REMARKS/DISCUSSION OF ISSUES

Amendment/Response to Office Action

ANNOTATED SHEET, FIG. 2

FIG. 2

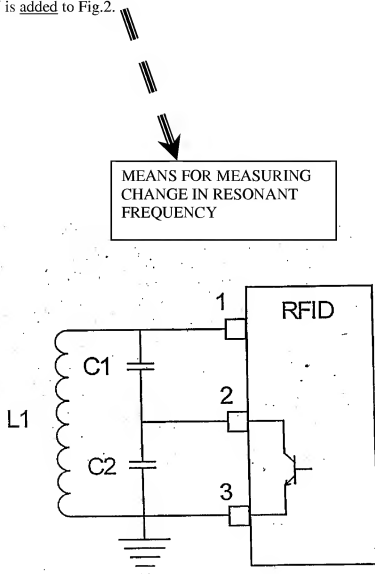
(a) The L-R-C circuit was replaced in claims by L-C circuit. The L-C circuit is shown in the drawings. For example, Fig. 2 shows L1 and C1 interconnected components representing L-C circuit of the present invention. A detailed description of this L-C circuit is provided in the specification, for example on page 19, Fig 2 brief description.

(b) The Examiner has requested to show the means for measuring the change in resonance frequency in Figures. The means for measuring the change in resonance frequency are shown in the attached amended Fig. 2 as a rectangular labeled box. As per 37 CFR 1.83a, Content of drawing, "...conventional features disclosed in the description and claims, where their detailed illustration is not essential for a proper understanding of the invention, should be illustrated in the drawing in the form of a graphical drawing symbol or a labeled representation (*e.g.*, a labeled rectangular box)." Support for the means for measuring the change in resonance frequency shown in Fig. 2 is found on page 33, paragraph 4; pages 34-36; page 39 paragraphs 4 and 5. No new matter is introduced by this amendment of Fig. 2.

A labeled rectangular box representing MEANS FOR MEASURING CHANGE IN RESONANT FREQUENCY is added to Fig.2.
